## **Make I-45 Better Coalition: Summary of Resident Comments (Source: NHHIP Interactive Map)**

The document below is a review of the comments from the NHHIP website's interactive map (<http://www.houstontx.gov/planning/nhhip/>) as of 9/15/19. The top portion of this document summarizes those comments generally and by segment. Continuing further down the document you can view most (impossible to guarantee that none were missed as there are many) of the comments as of 9/15/19, grouped into more localized sections of the map, not the three segments as generally defined. The presentation below shows a map followed by the comments from that map section.

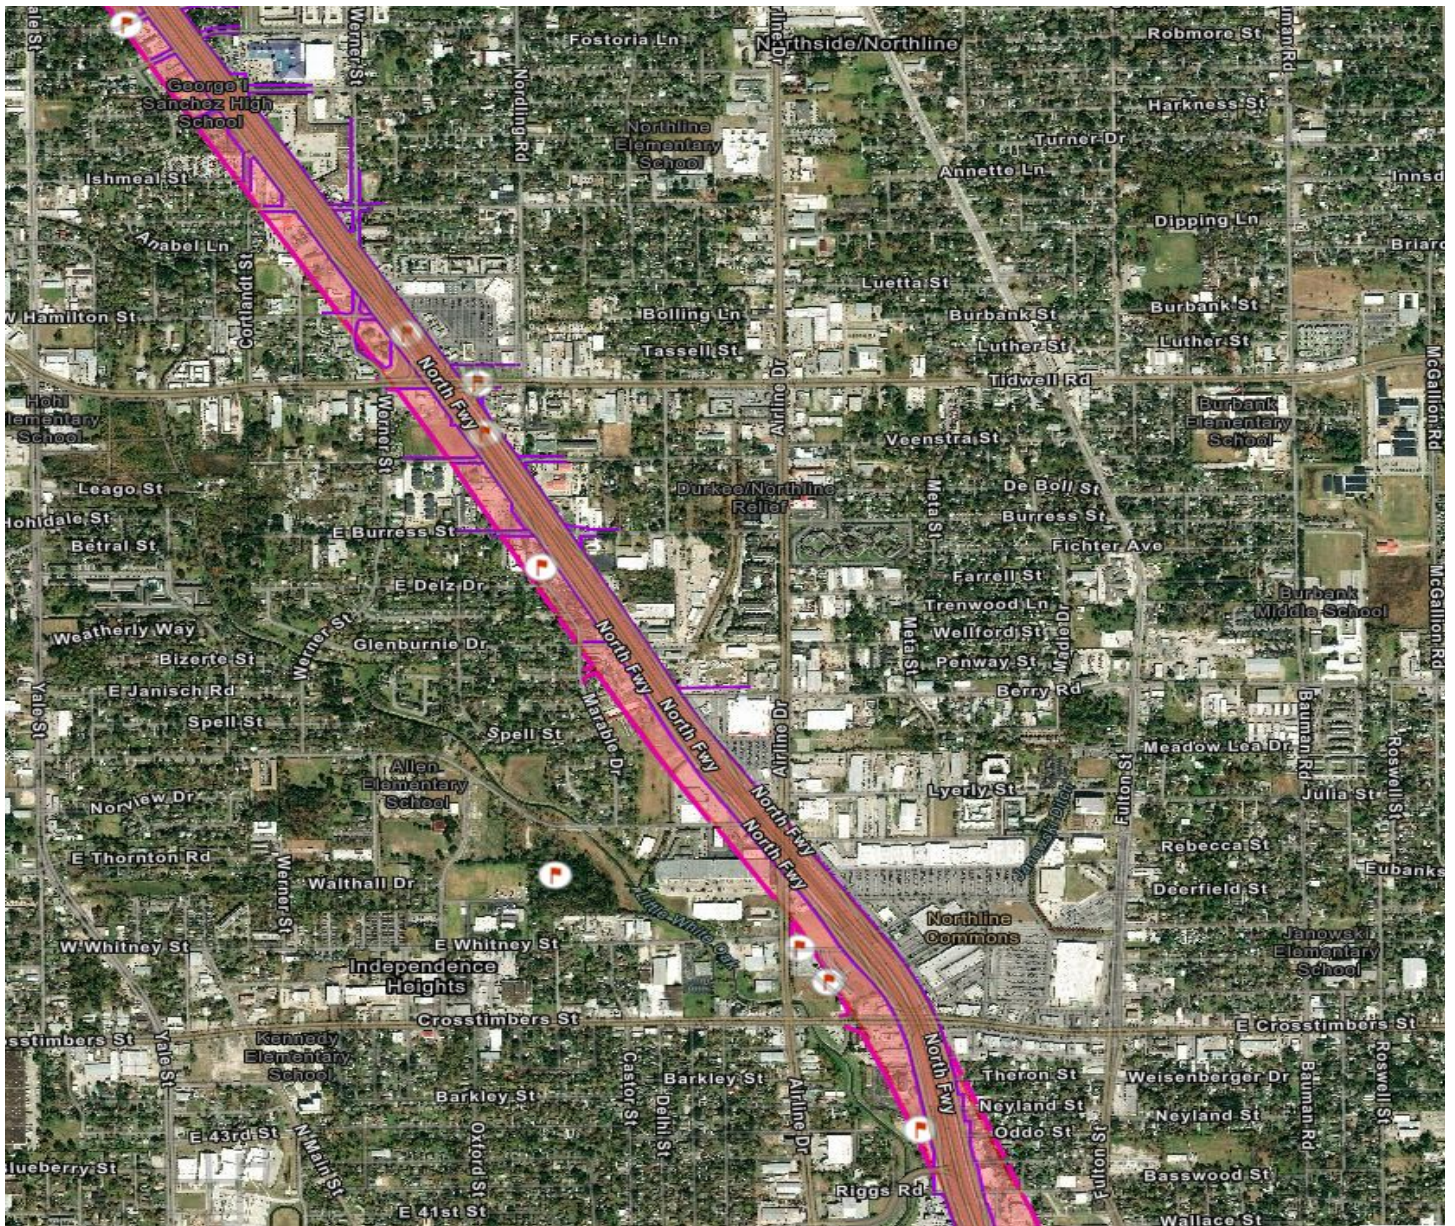
- Segment 2: This same interchange can exist in the current footprint. What is the point of this?
- Segment 2: Is there any justifiable reason to create this disruption to the ROW at this interchange? Keep the ROW the same and reduce property buyouts.

- Segment 2: Irvington and 610: Designs show the Irvington exit will be eliminated, this must not happen
- Segment 2: Overpass elevation: Mitigation measures? Trees, noise shields, help for home owners in upgrading homes for noise reduction ?

- Segment 1S: Fulton & 610: Overpass at light rail on feeder. MetroRail light is at 5 mins.
- Segment 2: Keep Irvington exit
- Segment 2: 610 and Irvington: Removal of Irvington exit would be extremely damaging to the Lindale neighborhood. How can this even be considered.

- Segment 2: West side of 3800 block Airline: This area used to be retention area for Old kelton Creek. this area also needs to be part of detention area for proper drainage. Flood water from north and west comes down through area. Other side of Airline will not be enough. Restore natural flow.

- Segment 1 South: What if exit for Airline/Victoria started earlier? Then you have a flying exit for Crosstimbers- it has too much traffic not to have its own exit

- Segment 1 South: Needs to be retention (clump of trees along white oak between east whitney ST and Victoria
- Segment 1 South: Widening the freeway this much through Independence Heights is ridiculous and should not be acceptable. Why do we continue to burden historic black neighborhoods with impacts of freeways. **Displacement**

- Segment 1 South: I-45 Crosstimbers through Parker: The feeders from Crosstimbers to Parker flood easily making the frontage roads impassable. This needs to be addressed.

- Segment 1 South: I-45 Northbound between entrance and exit ramps: The current design plans will make this area of the northbound lanes a bottleneck and an accident hot spot. Please change the design to add a 5th freeway lane both northbound & southbound and eliminate all forced merges

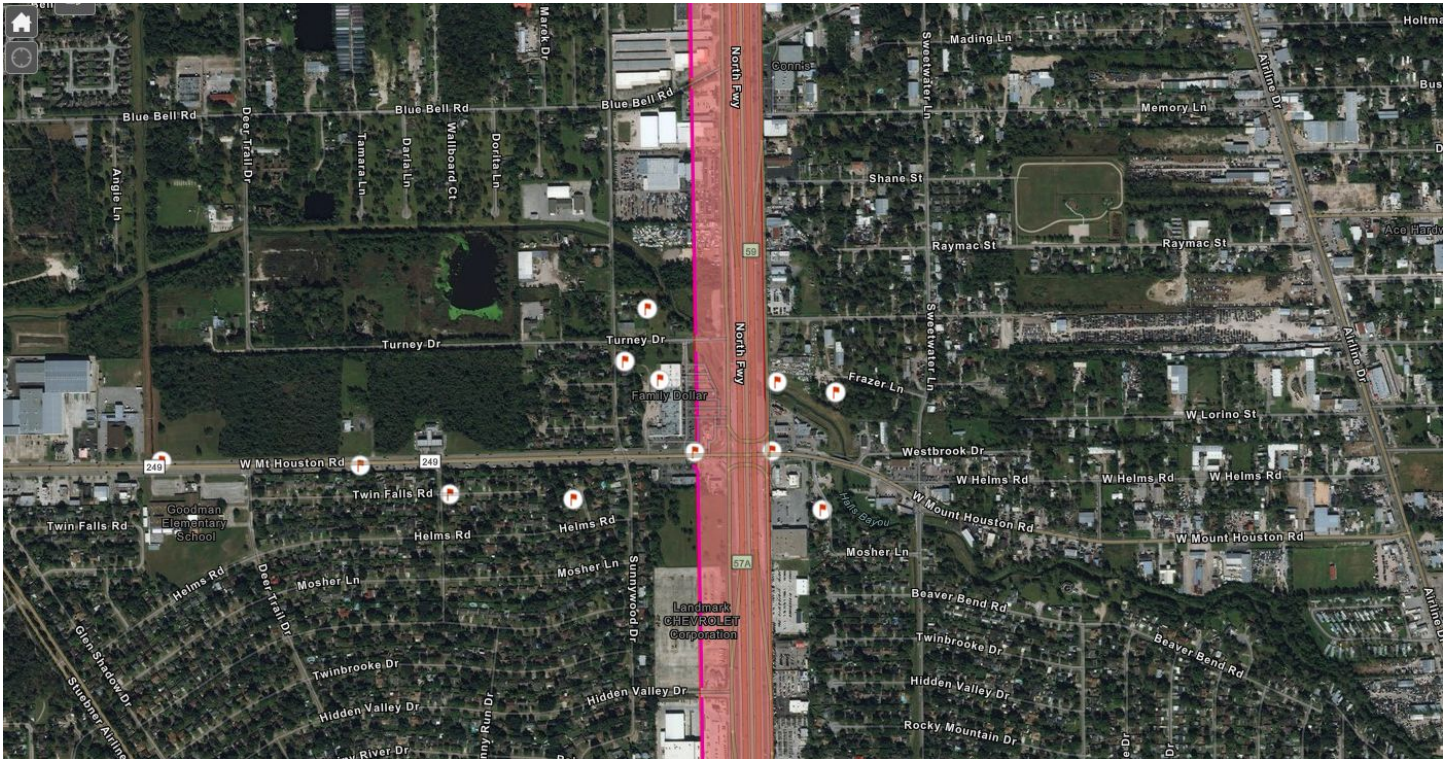
- Segment 1 North: Frontage Road drainage is slow after rains, which causes drivers exiting freeways to clash with drivers attempting to avoid huge water puddles.
- Segment 1 : We bought this building 5 years ago, we spent 7.8 million dollars to convert it into a food facility and the City of Houston never told us about this project.
- Segment 1 :Protect Houston Community College
- Segment 1 : What will happen to Houston Community College when I-45 is expanded? It floods in this area. Need to correct this and make sure college is safe and secure.
- Segment 1 North:Where is the Little York exit? Will it be removed?
- Segment 1 N: Massive Flooding - Retention Pond - Detention Ponds do not work - Wrong type of detention pond - need to correct this.
- Segment 1 : How does the expansion of I-45 affect the Shepherd fly over on ramp to I-45 Northbound?

- Segment 1 : Massive Flooding - Retention Pond - Detention Ponds do not work - Wrong type of detention pond - need to correct this.
- Segment 1N: I-45 and N. Shepherd/Veterans Memorial: There should be a direct connection from I-45 North to Veteran's Memorial. Currently, you have to exit Little York and take Victory Dr. to N. Shepherd to access Veteran's Memorial. Why not fix this circuitous routing?
- Segment 1: The entrance ramp that merges at this location, can be relocated to location (B)
- Segment 1 : Massive Flooding along feeder at Gulf Bank Road. Wrong type of detention pond used, need to correct this.
- Segment 1N: Flooding Area
- Segment 1N: Correct drainage for frontage road, we always flood.
- Segment 1N: Mitigate flooding at Gulf Bank/45

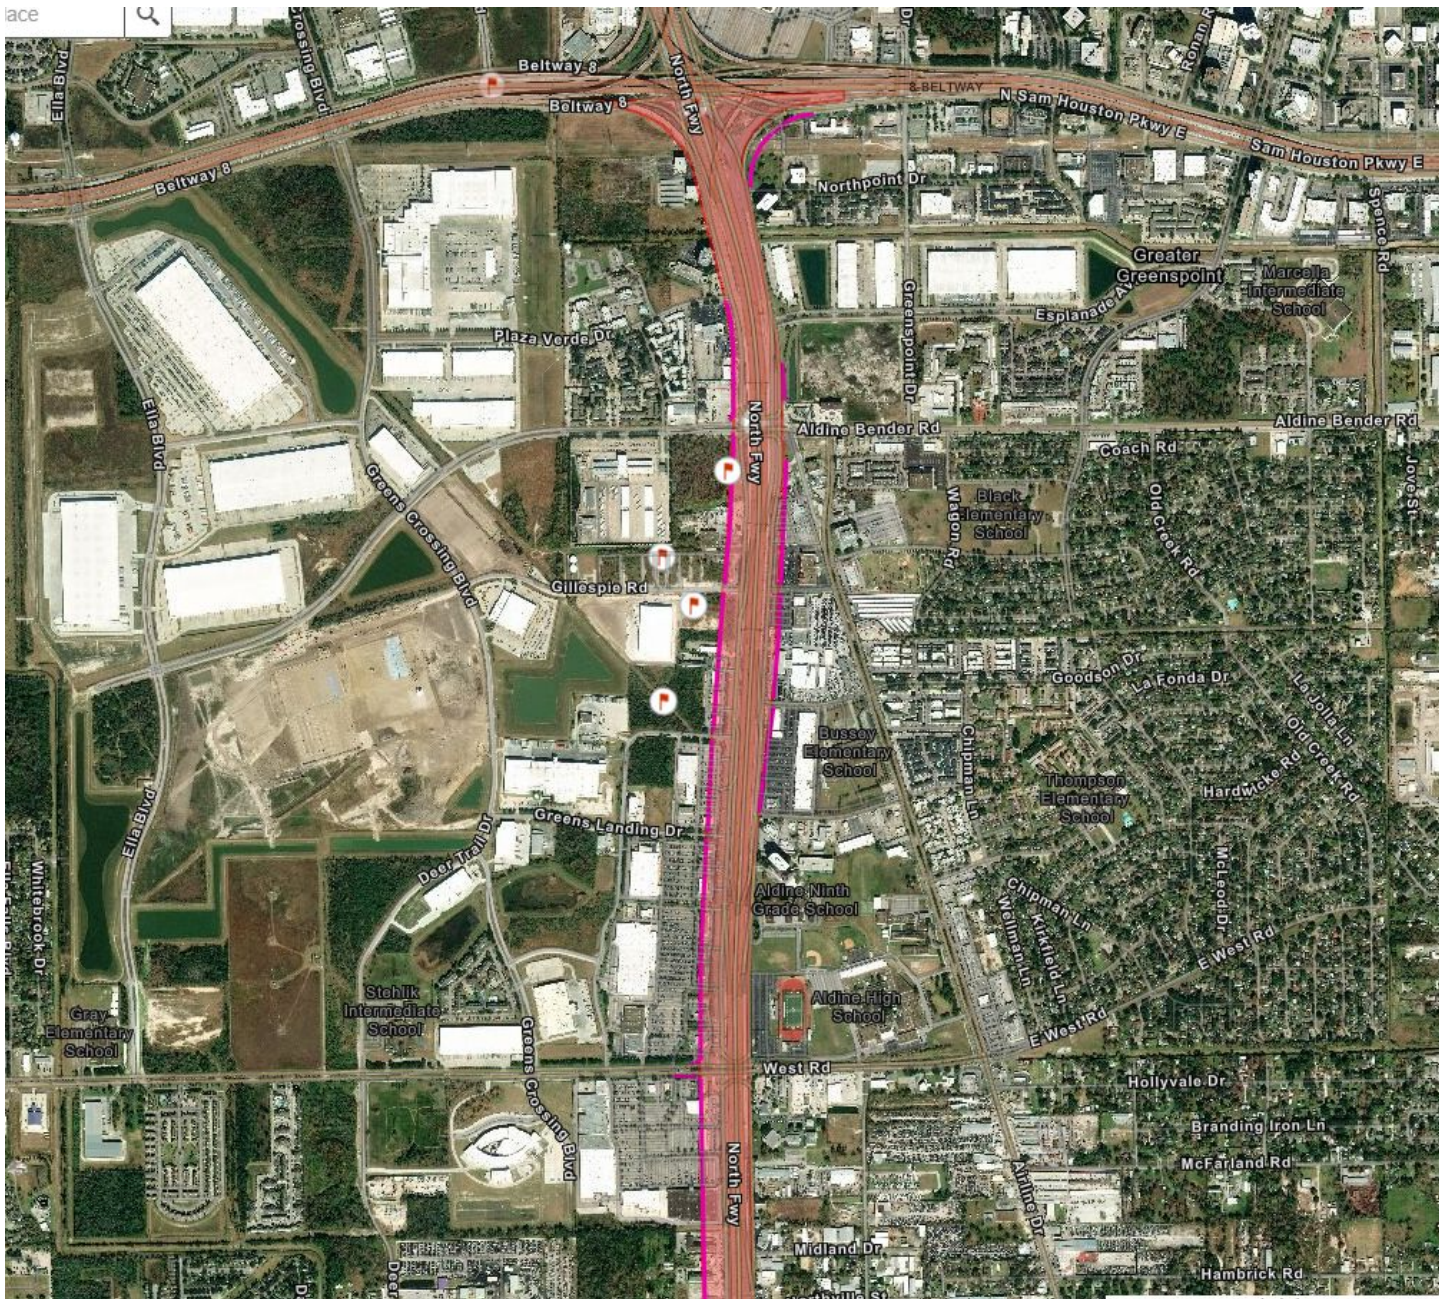
- Segment 1 N: Improve drainage from here to I-45 (Mt Houston Road)
- Segment 1: Start Aggie Hwy here, to remove Tomball traffic from I-45.
- Segment 1: Massive flooding - West Mount Houston (249) wrong type of retention, detention pond - need to correct this.
- Segment 1: Floods in this area!
- Segment 1: Correct drainage to make sure we can exit.
- Segment 1: Flooding in this area.
- Segment 1: Flooding in this area!
- Segment 1: How to access MAX/connect to and from 249? Direct connections - you mis-matched the exit /entrance for I-45 MAX access.
- Segment 1: Plan to address chronic flooding at this intersection?
- Segment 1: Add bikeway (along bayou under I-45)

- Segment 1: Flooding / Drainage: What happens when all of this hardscape is added? Will it affect flooding issues? The City needs to be more porous (flood reinforced).
- Segment 1: Add BRT along I-45
- Segment 1: Auxiliary lane is not balanced. Traffic bottleneck!
- 
- 
- Segment 1: @ Fllbrook: The direct connector lane exits into feeder road. That means more traffic is merging into the freeway than exiting. That causes the current bottleneck at this location and the only way to eliminate the bottleneck, is to add a 5th lane.
- Segment 1: Bad intersection, merging traffic here
- Segment 1: HCTRA could incentivize travelers avoid downtown by charging little or zero toll for people getting on BW8 at I-45 on one side of town who then also pass through a toll station on the opposite side of Houston the same day within a time window.
